# CONNECTICUT RESOURCES RECOVERY AUTHORITY

## ADDENDUM NO. 1 Issued March 16, 2006

### CONTRACT DOCUMENTS FOR OPERATION AND MAINTENANCE OF THE HARTFORD LANDFILL GROUNDWATER FLOW CONTROL SYSTEM 180 LEIBERT ROAD HARTFORD, CONNECTICUT

TYPICAL PUMP INSTALLATION

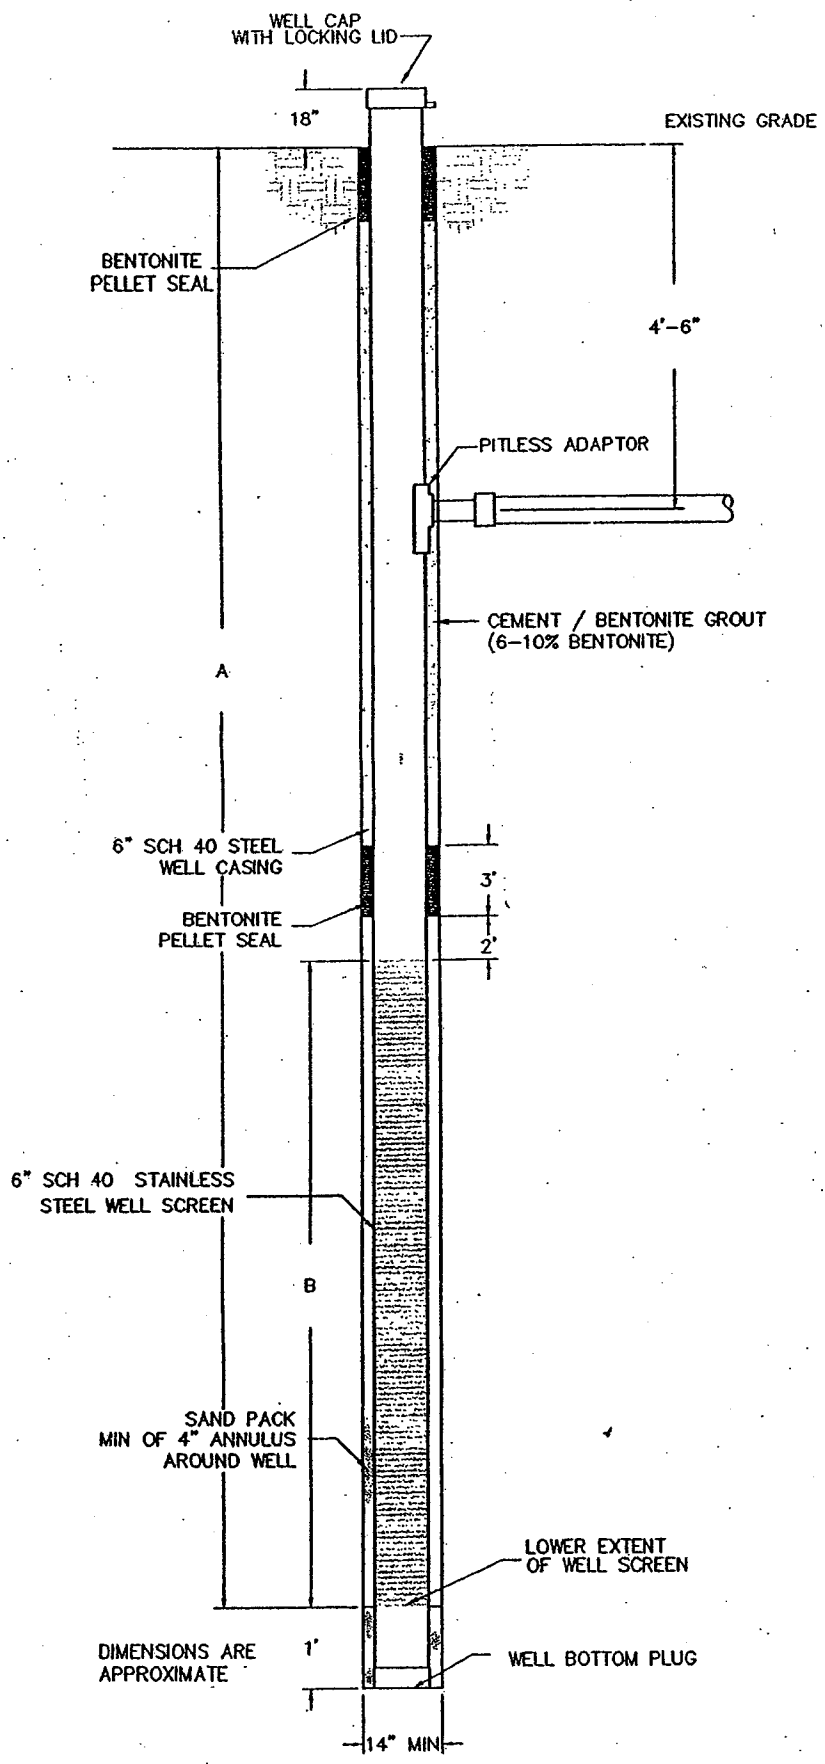
- Q6. Will you please provide copies of drawings depicting the construction of the pumping wells and the piezometers?
- A6. Please see the three (3) pages in Attachment #1 to this Addendum No. 1 for the requested drawings.
